Cosmopolitan Industries PVT Ltd (Epic) New Shed

9th December 2020

Building Information

1. Warehouse Building (G +1, Mezzanine at both floors)

Column layout plan

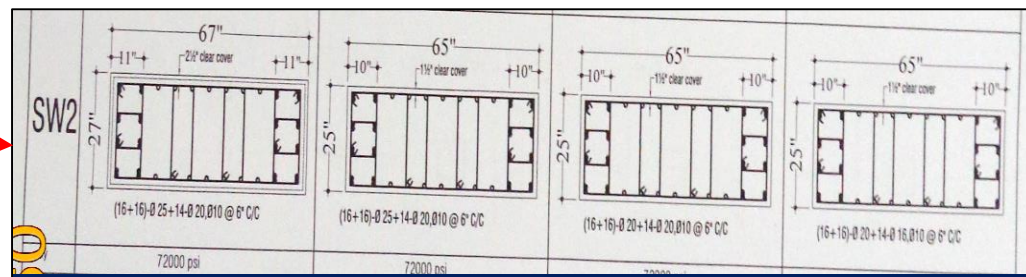
Shear wall has been assigned at grid 1/B. The depth of the shear wall is 1625 mm and width is 625. So, the ratio of depth to width is 2.6. So, building engineer is required to provide the justification with proper reference for considering the member as shear wall instead of column.

As per BNBC every building or structure designed shall have its design documents prepared in accordance with the provision of Section 1.9.1. The design document shall include a design report, and a set of structural drawings, which shall be prepared in compliance with section 1.9.1.1 and section 1.9.1.2 as per BNBC. Factory engineer is required to revise the design documents and recheck the serviceability of the structure based on justification with proper reference.

Signage of water ponding at roof

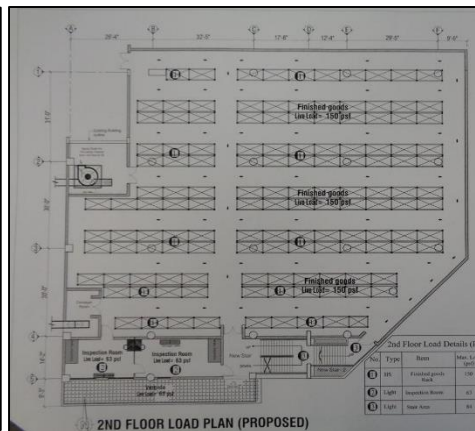
Signage of water ponding was found at roof due to construction of water proofing with improper slope. The factory engineer to improve drainage system with a proper slope on roof slab to prevent water ponding.

Permit drawing for 3 storied from Union Porishod

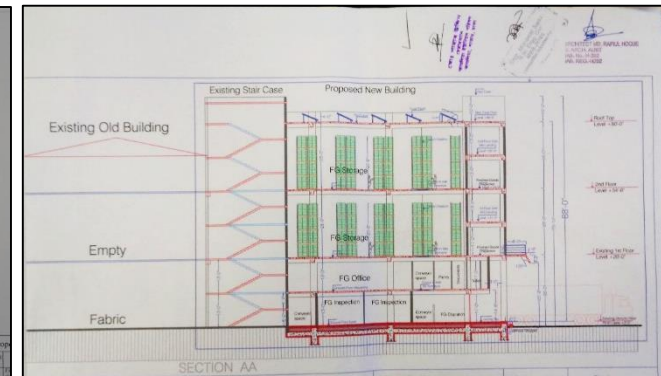
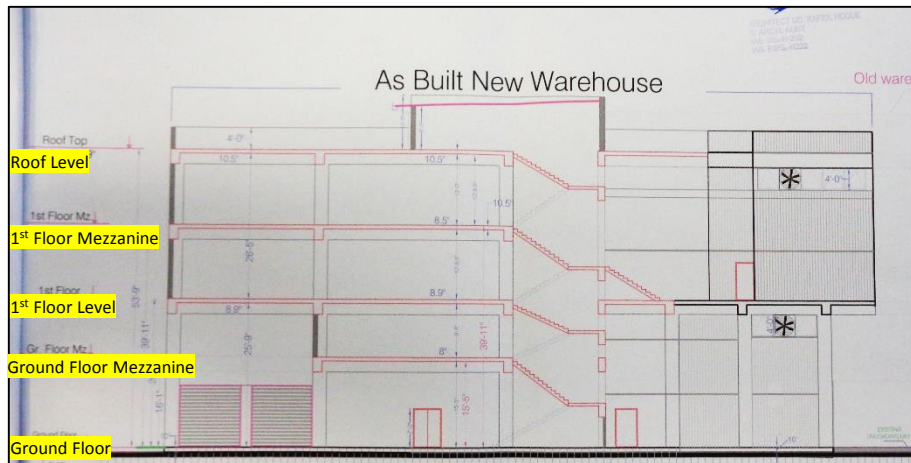
The building permission layout is for 3 storied structure. Also, the design report of the structure was prepared for 3 storied structure. Till the date of this inspection, Building was constructed up-to two storied. So, there is a possibility of future vertical extension. But no Architectural & Structural drawing was found for the 3rd storey. Factory engineer is required to prepare full set of drawing & documents for the three storied structure prior to commencement of further extension work.

Item No.	Observation	Recommended Action Plan	Recommended Timeline
7	Future Vertical Extension	Prior to vertical extension, factory engineer is required to produce Detailed Engineering Assessment(DEA) of the structure according to BNBC and submit to RSC for review.	6-weeks
8	Future Vertical Extension	Carry out recommendation as outcome of the DEA.	6-months
